LAKE NEEPAULIN DAM NJ 00282

PHASE 1 INSPECTION REPORT NATIONAL DAM SAFETY PROGRAM

LAKE NEEPAULIN DAM (NJ000282)

CORPS OF ENGINEERS ASSESSMENT OF GENERAL CONDITIONS

APPROVED OCT 13, 1926
PLAN OF DAM
LAKE NEEPAULLIN
Wantage TWP Sussex Co. N.J.
Scale as shown Aug 1926.
Snook & Hardin Engr's
Newton, N.J.

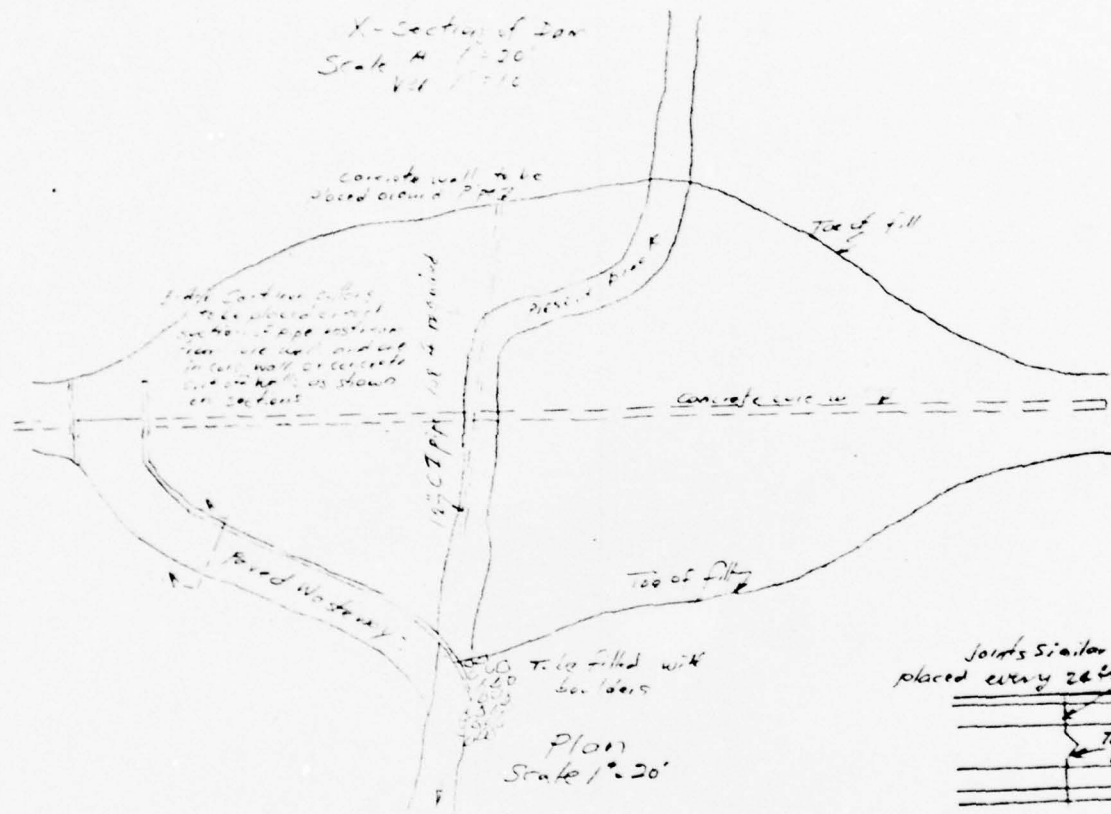
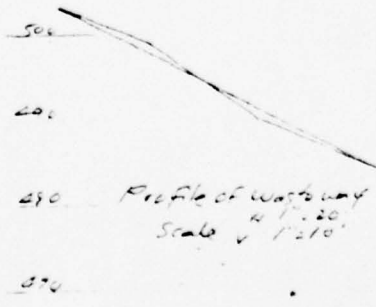
The present spillway structure discharge channel, and outlet pipe are not as shown on the design drawing. The spillway has been constructed closer to the center of the dam and a plunge deflector added. The pipe outlet is only 2 feet below reservoir level. The discharge channel was never completed.

(1) The existing dam plans and drawings should be annotated and updated to form a coherent as-built set.
